ADDENDUM NO. 1 TO BID NO. 13-0107-4

FOR: CLOVERDALE COMMUNITY CENTER

PLEASE SEE THE FOLLOWING FOR ADDITIONS, CLARIFICATIONS AND/OR CHANGES:

A-3

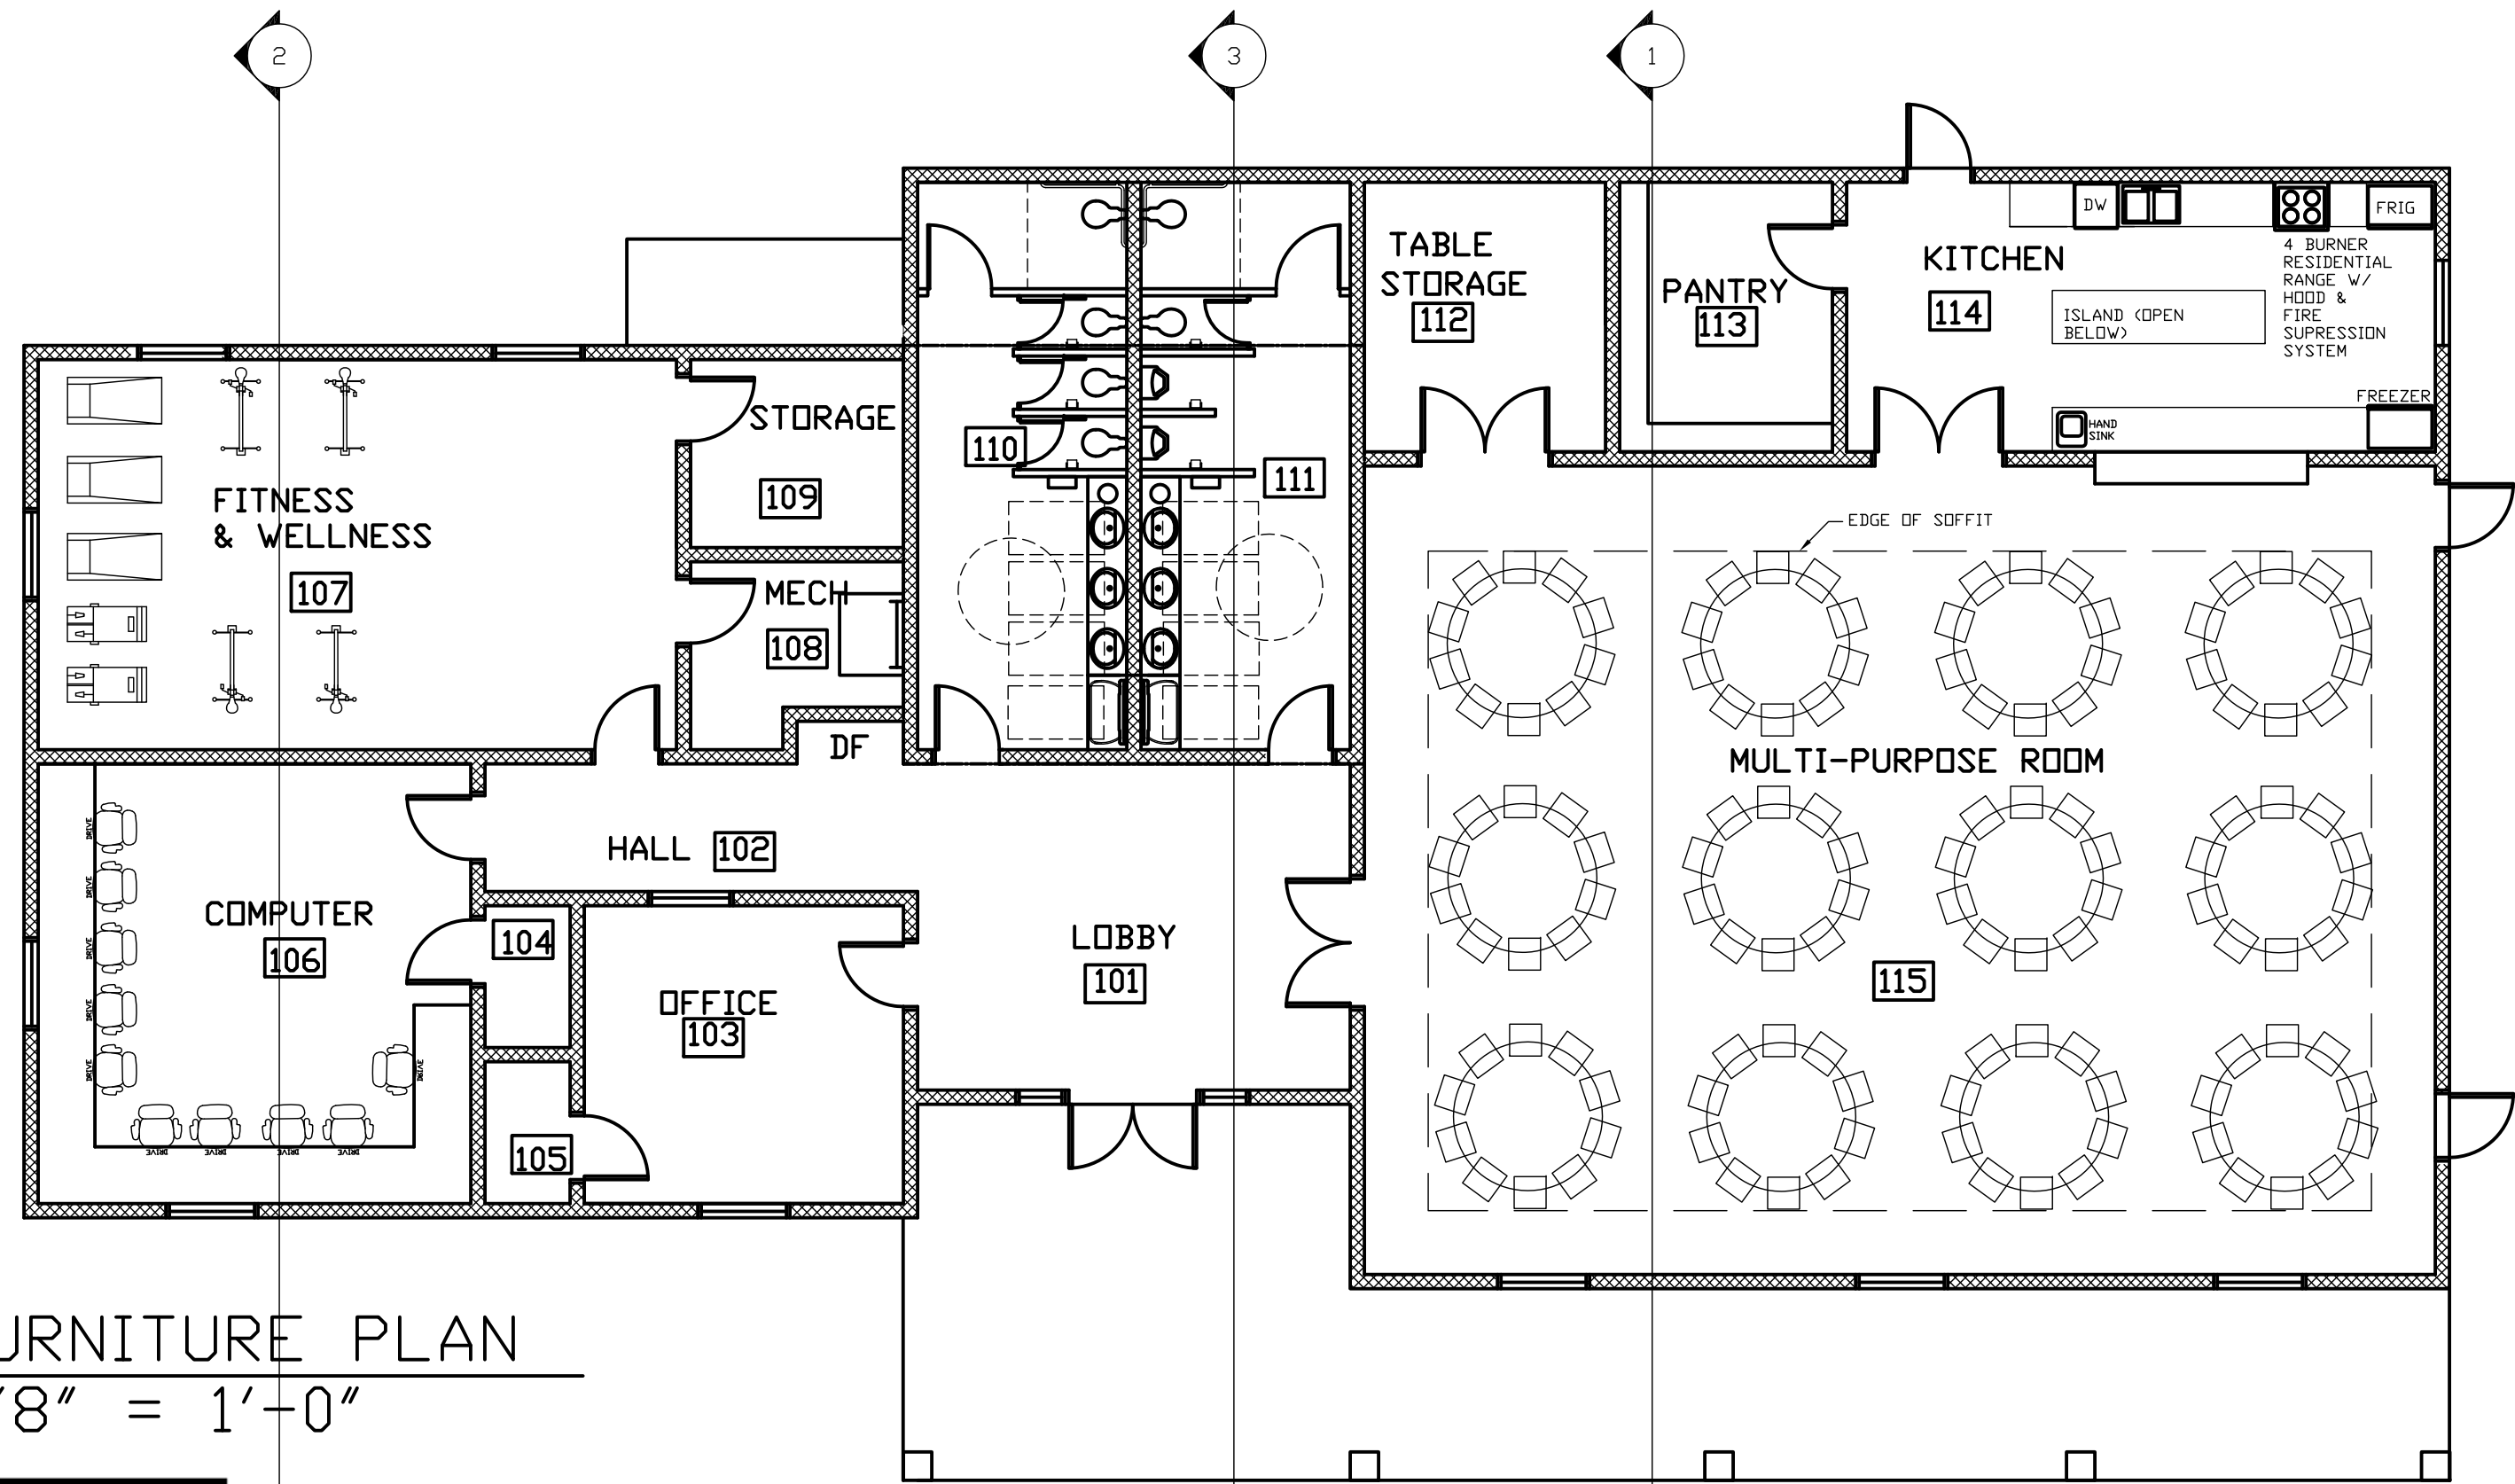
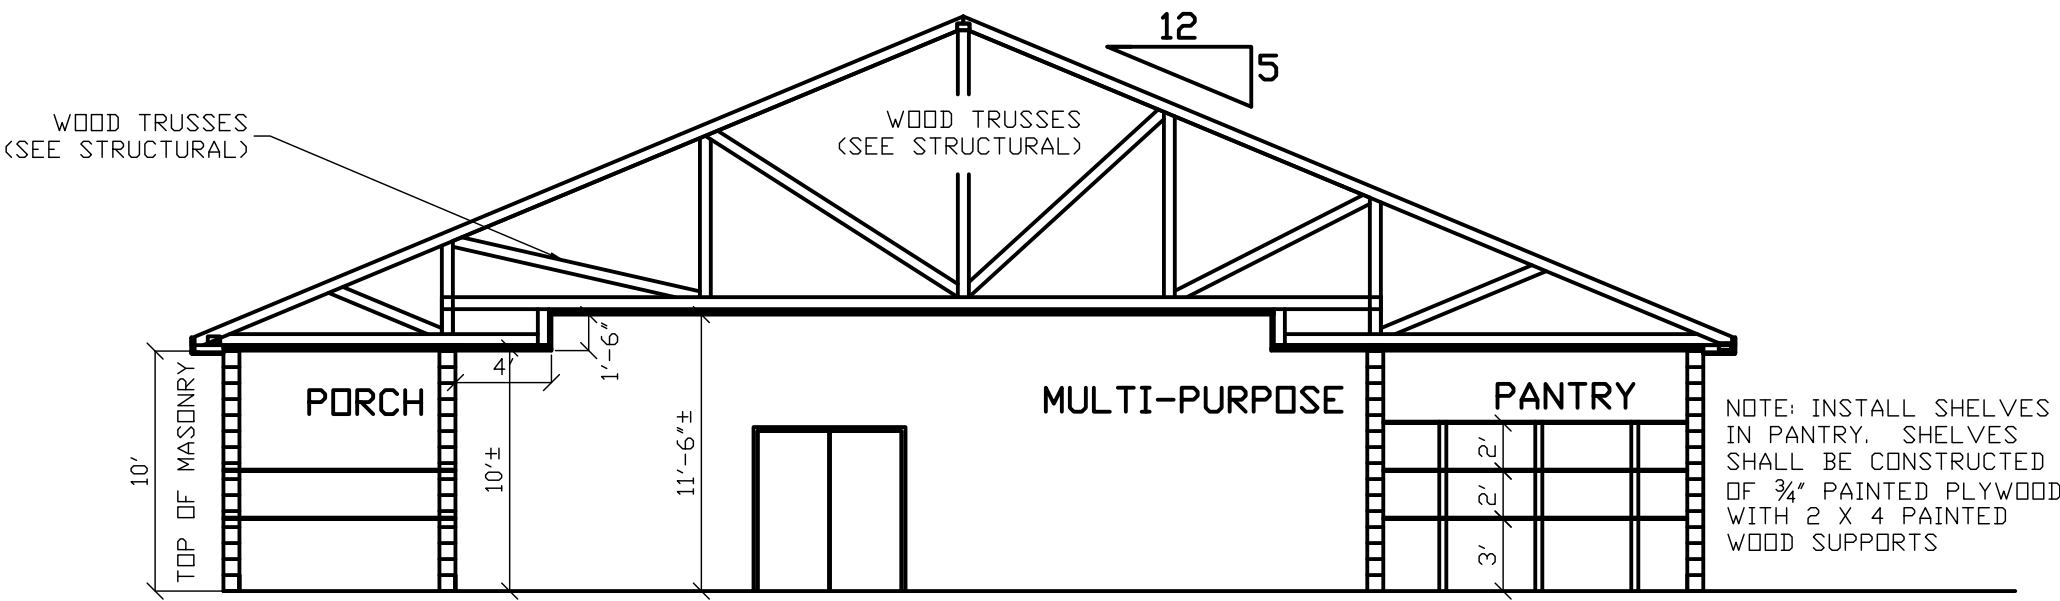
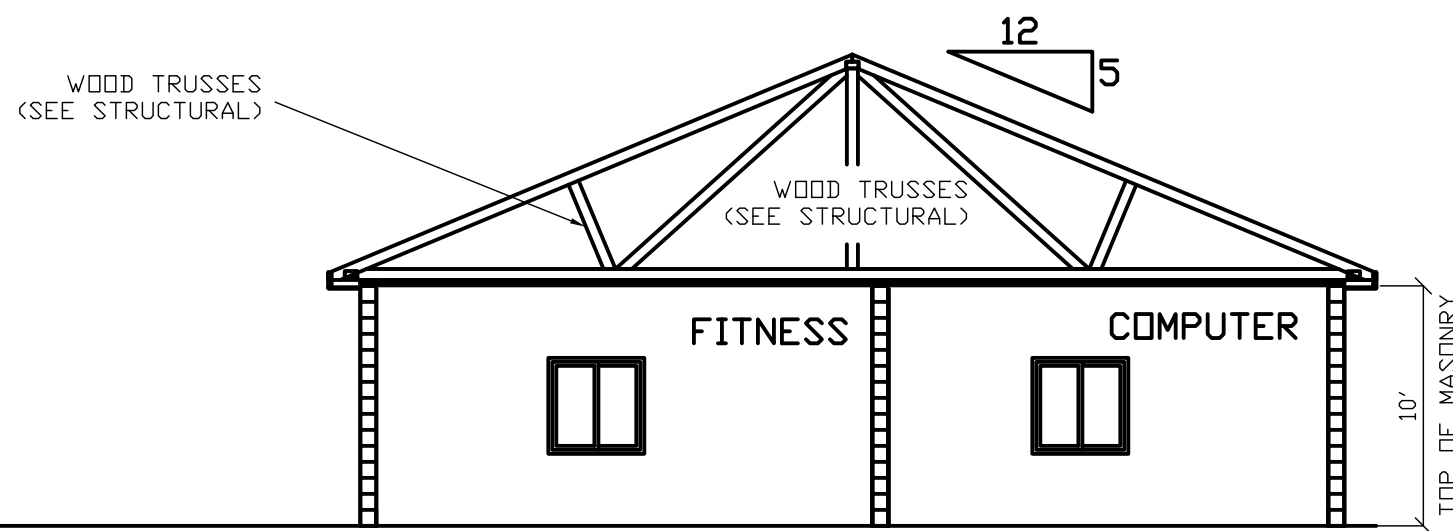
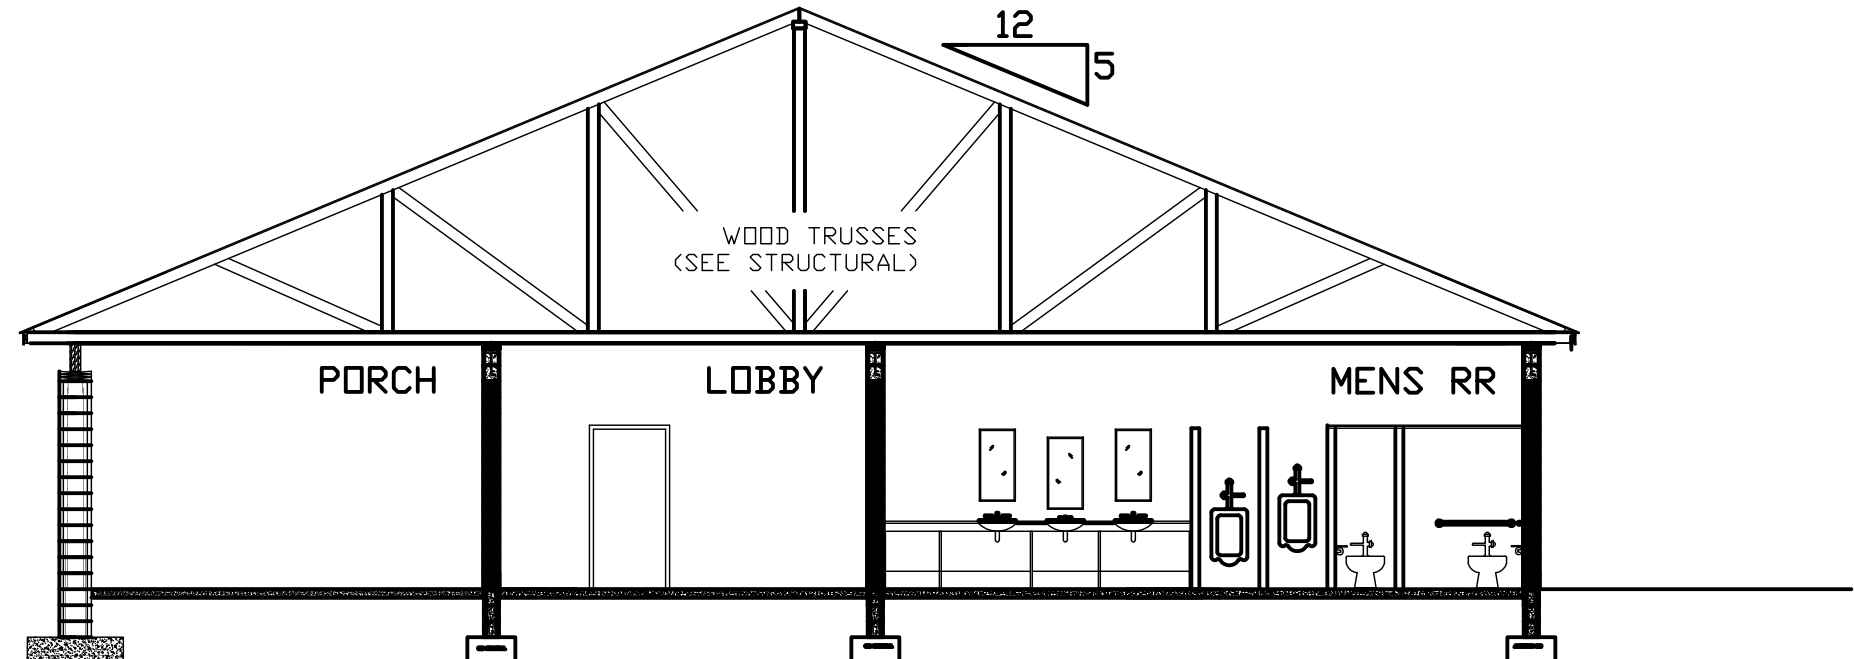
3. Q) What is the hardware to be for the aluminum storefront doors ?

A) *Entrance storefront hardware: See revised sheet A-3. Mid-rail, flush panic device with manufacturer provided locking.*
